MODEL 2101

RELEASE - POST FOR CHAIN BRAKE

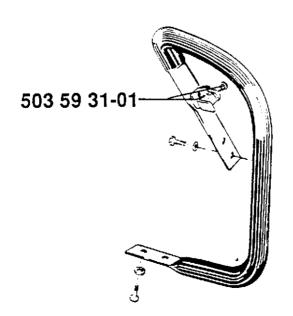
The release mechanism mounted on the front handle is changed, in order to receive a better function of the chain brake.

Introduced from serial number 9350057.

New Ref. No.	Description	Excluded Ref. No.
503 59 31-01	Release-post (kit)	501 61 55-02
		501 61 56-03
503 41 51-01	Chain brake	* 503 41 51-71
		501 48 59-01
		501 69 06-01

^{*} Previous enclosed screw is excluded.
